CREEKSIDE AT LORSON RANCH FILING 2

PLANNED UNIT DEVELOPMENT AND PRELIMINARY PLAN

PUD TITLE SHEET

PUD Development Plan_v1.pdf Markup Summary 6-2-2022

CS01

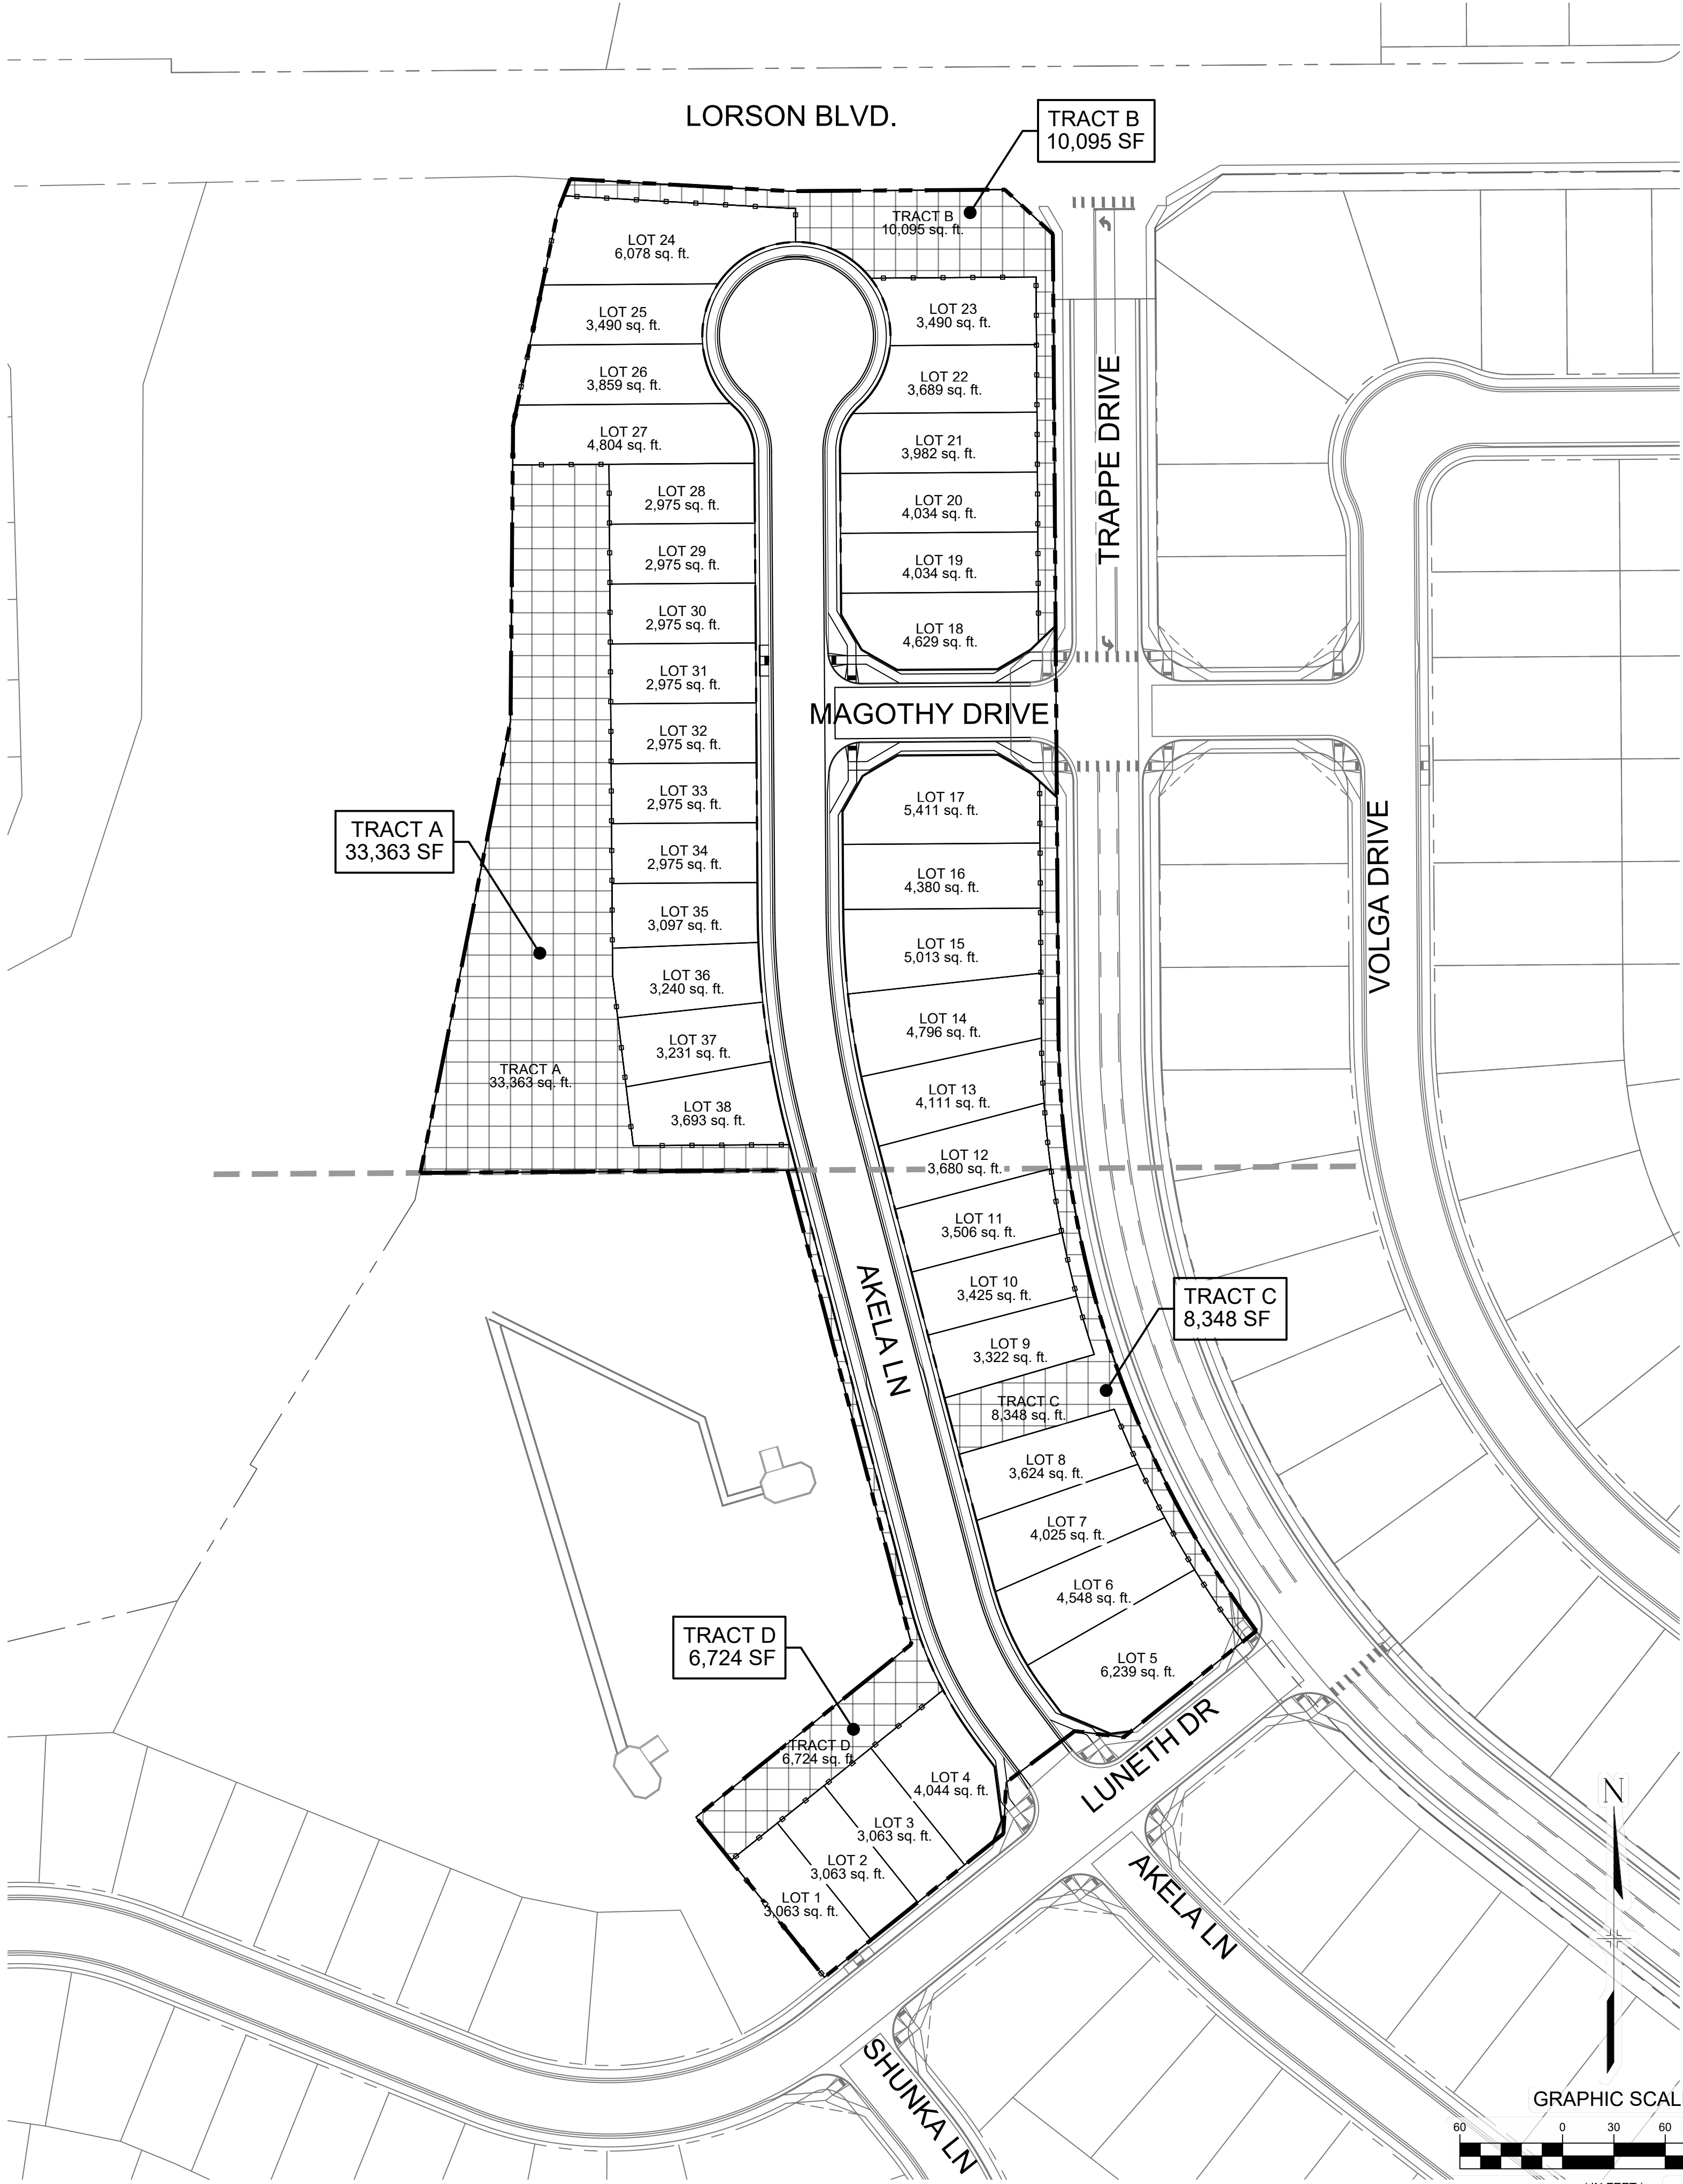
Add applicable notes.

TIE INTO STORM
SEWER ON CDS
AND STATE WHO
MAINTAINS

I think this is not
correct outline map
for the vicinity map of
project.; please
provide in contact of
all of Lorson

Shown as 15 ft on sheet 3. Please revise one of the two dimensions to match.

DT01

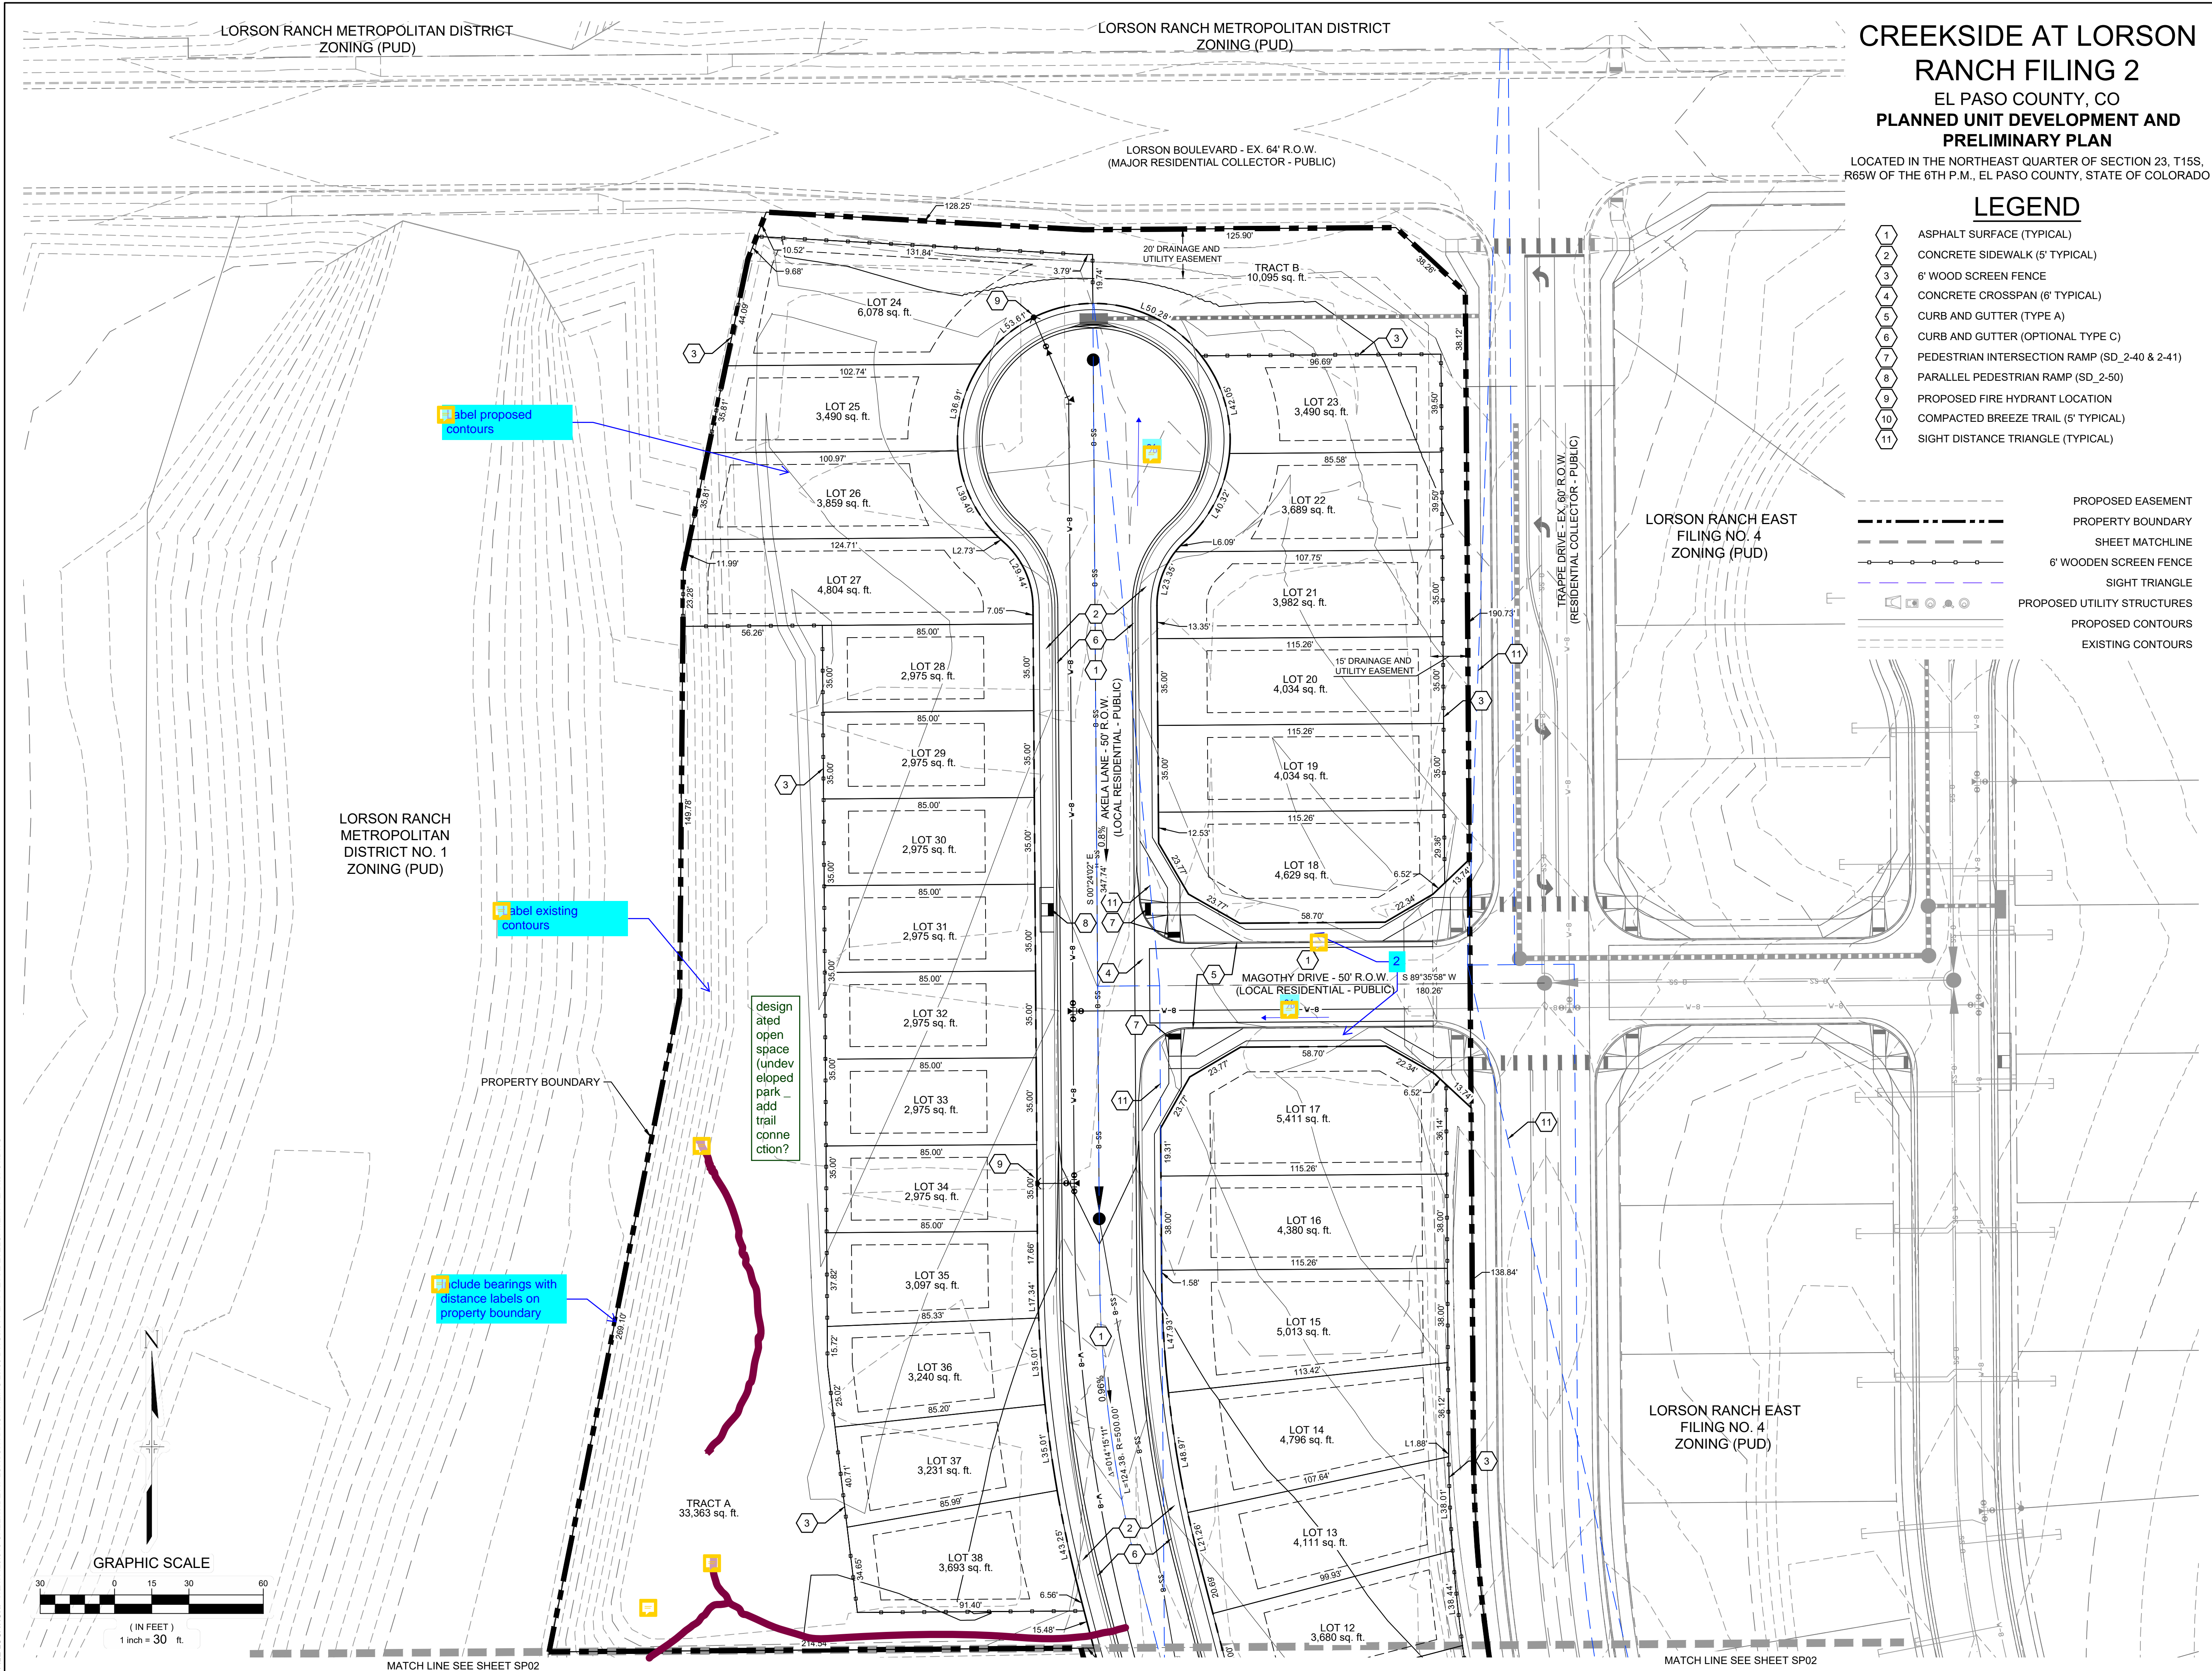
here is the
dedicated 25%
requirement of open
space for recreation
only not
utilities/drainage per
Code?

this is really not
landscape, nor park,
its drainage maybe 1" X 4" VERTICAL PICKETS

SP01

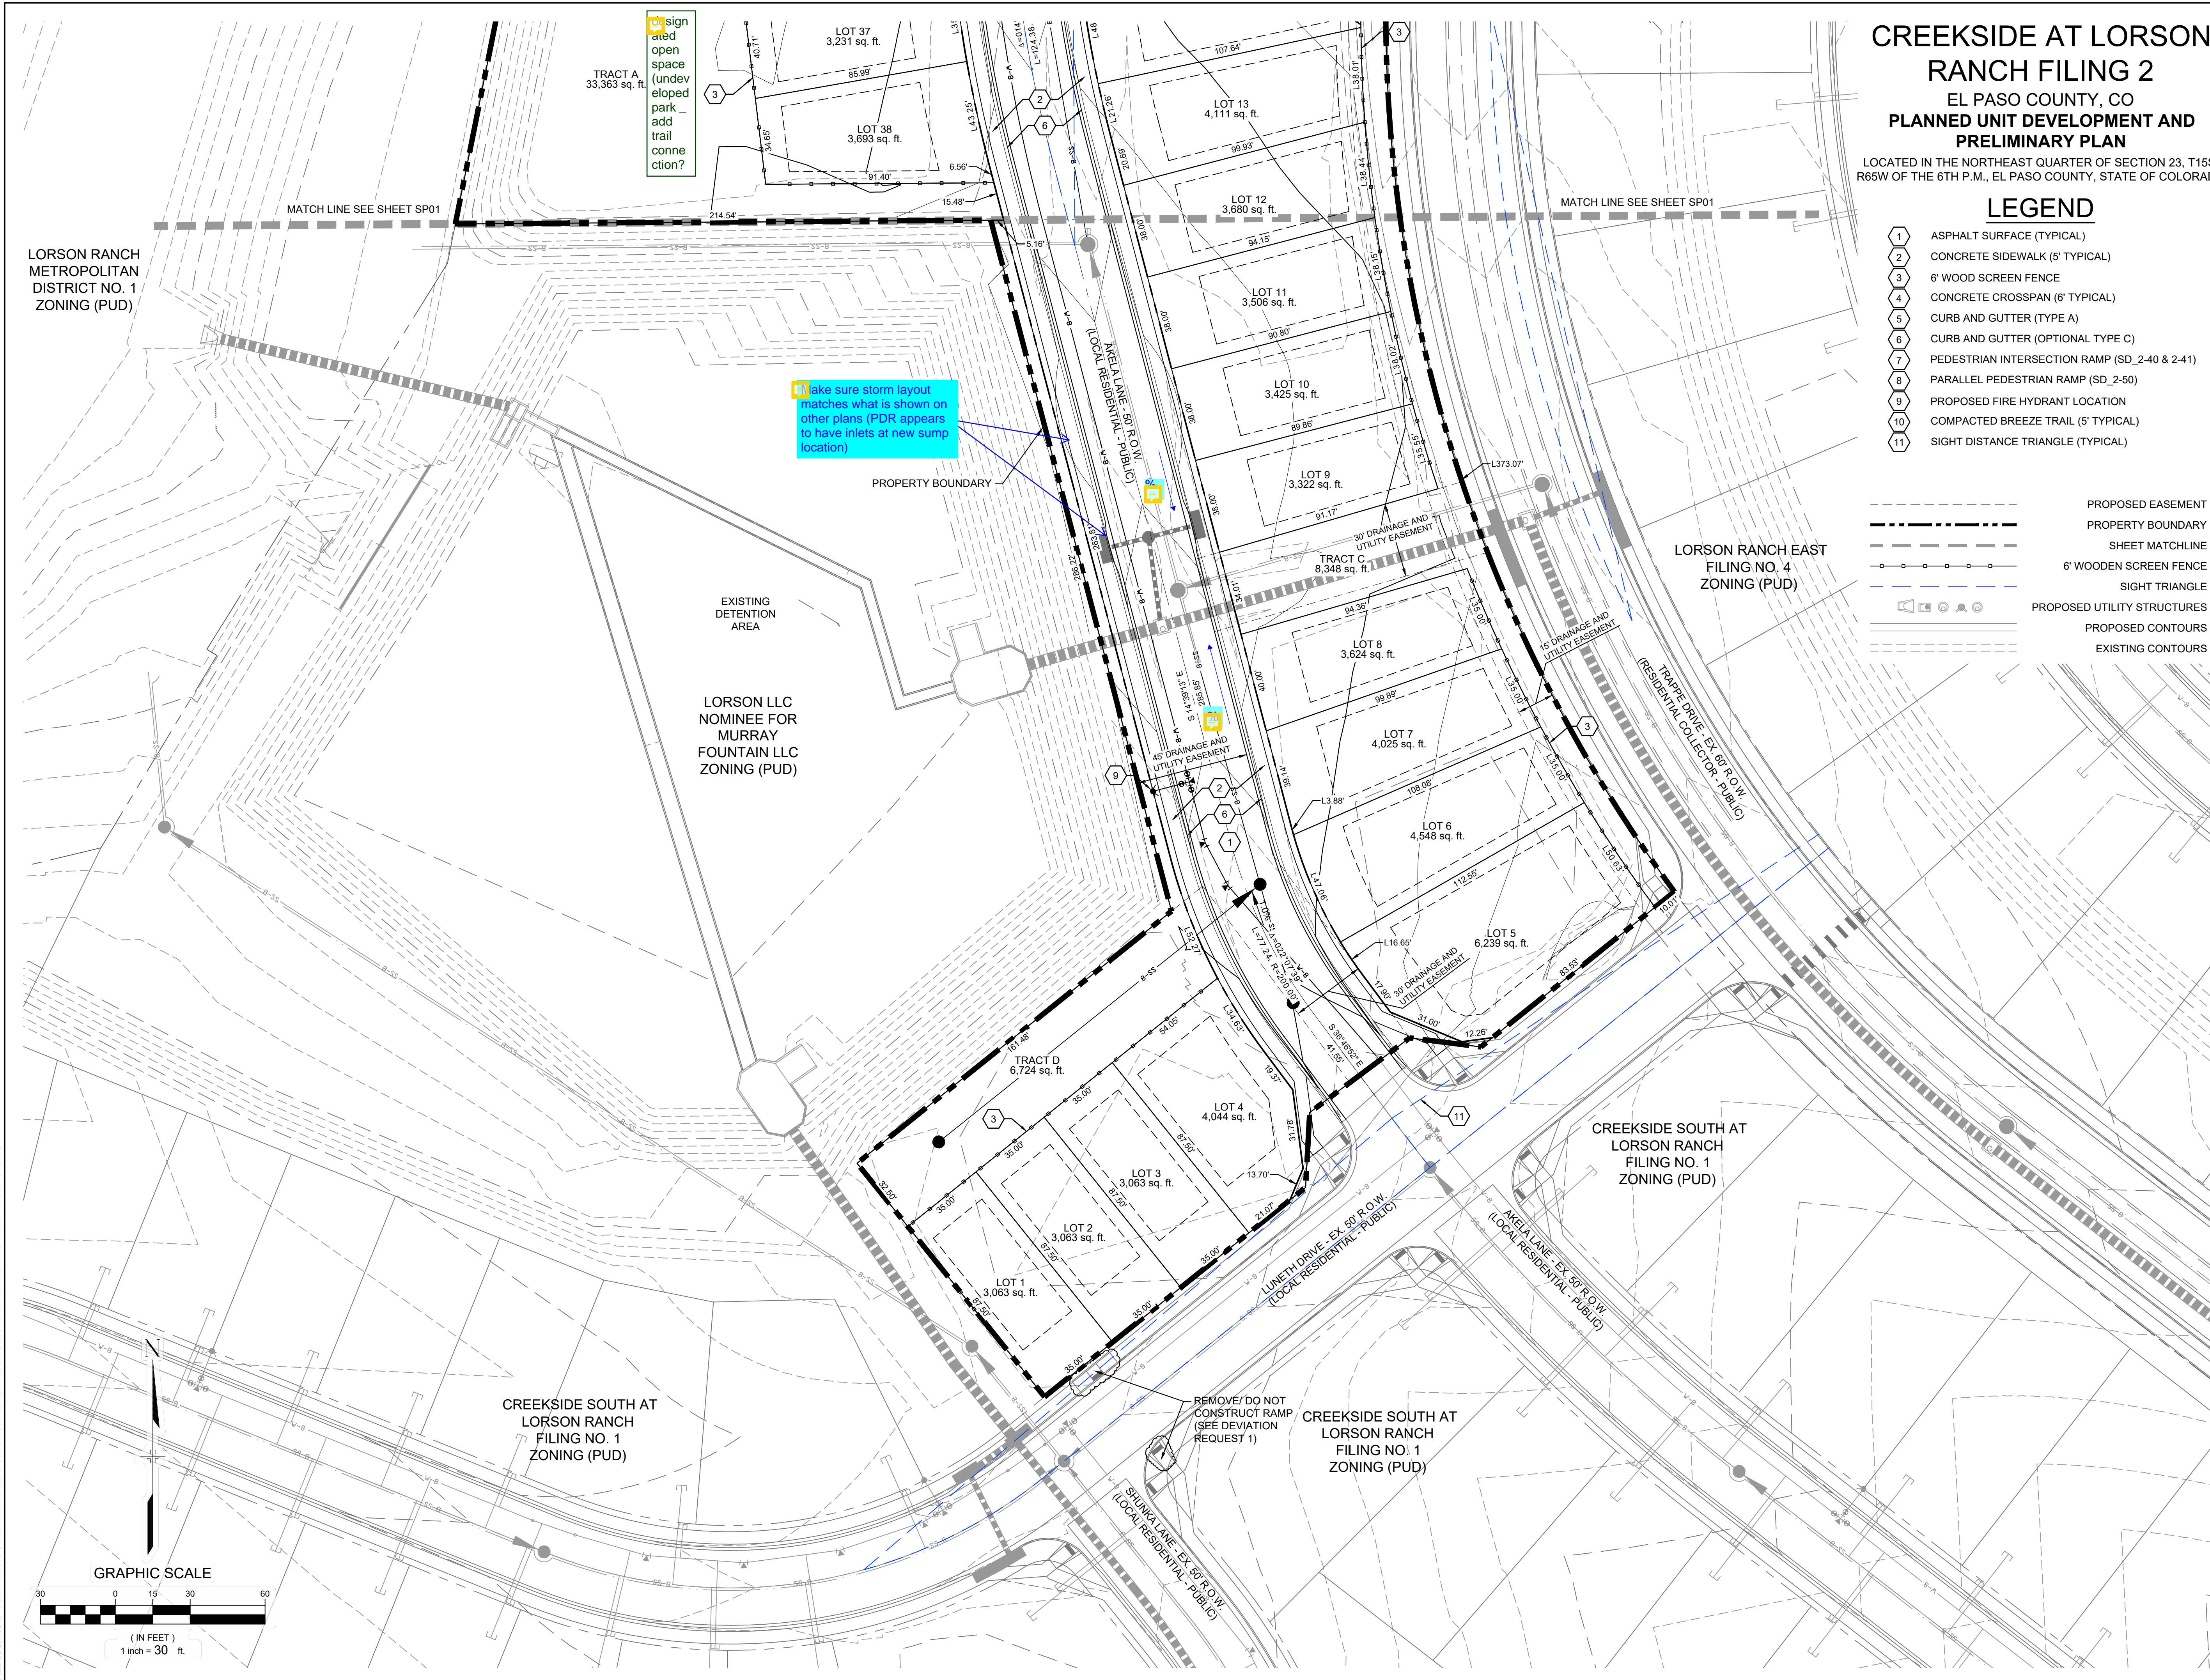
Include bearings with distance labels on property boundary

Label existing contours

Label proposed contours

Make sure storm layout matches what is shown on other plans (PDR appears to have inlets at new sump location)
